SERVICE INFORMATION

Number: 471-9011

Gear selector shaft oil seal, manual transmission

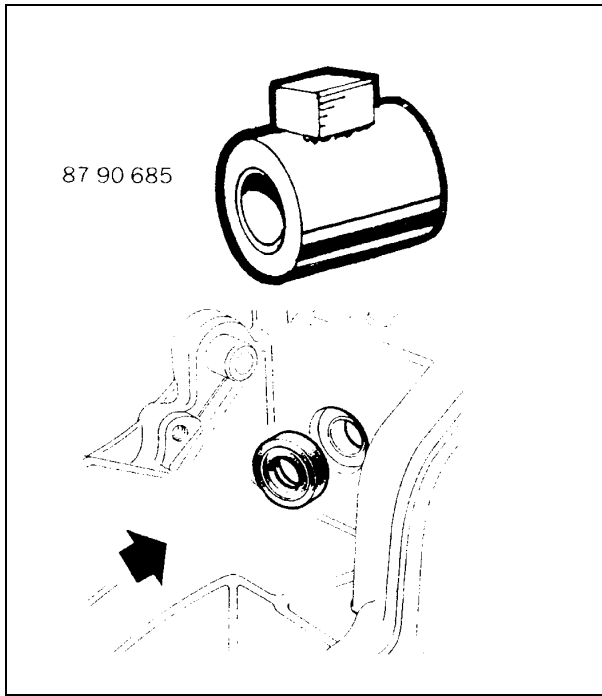
A new gear selector shaft oil has been introduced to solve leakage problems. In 1994-98 with manual transmissions, the seal can be changed while the transmission is in the car. Refer to the procedure below to change the seal.

Change the gear selector shaft seal as follows:

- 1 Select 4th gear and disconnect the gear shaft coupling.
- 2 Select 3rd gear and by using a suitable hooked tool, remove the old seal.
- 3 Check the surface of the shaft and remove any imperfections.
- 4 Starting half way down the shaft, wind a length of electrical tape around the shaft to protect the seal lip and install the new seal.
- 5 Using tool, P/N 87 90 685, tap the seal ensuring it is perfectly square in the housing.
- 6 Refit the selector shaft coupling and check alignment of the gear positions (see Service Manual 4:1, page 432-4).
- 7 Check/top up the gearbox oil level and test.
